PCN – Product Change Notification

Document No	PCN-A-080919	Revision	1.0		
-------------	--------------	----------	-----	--	--

ECN Topic: New 12.1 inches Open Frame Dimension_W12L100-OFM5

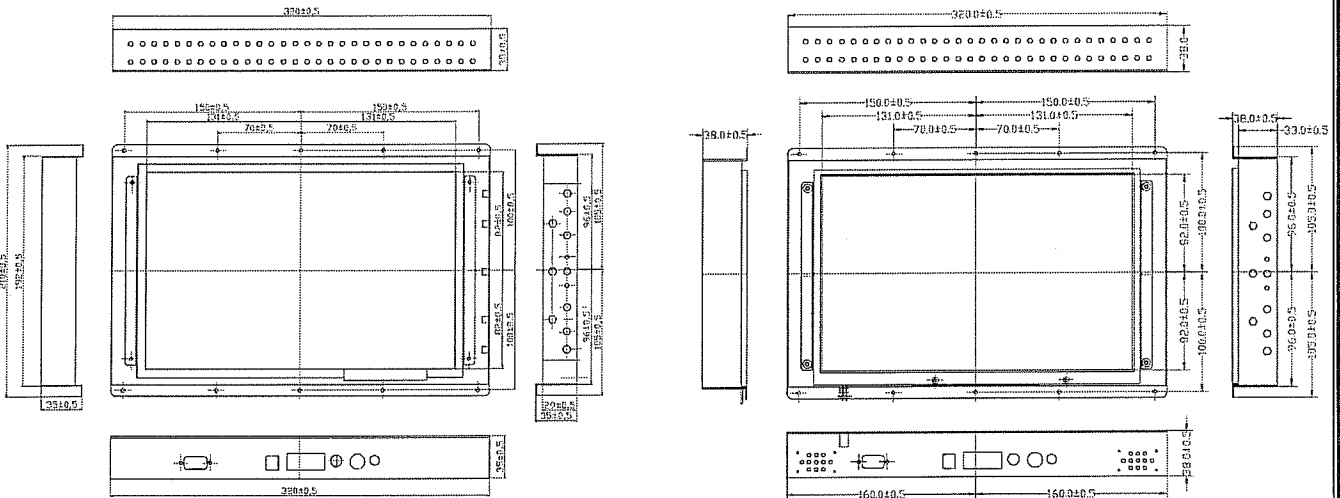
The dimension of mechanical will change from 320 x 210 x 35 mm to 320 x 210 x 38 mm. The below pictures show the example of how the new mechanic differ from Original one.
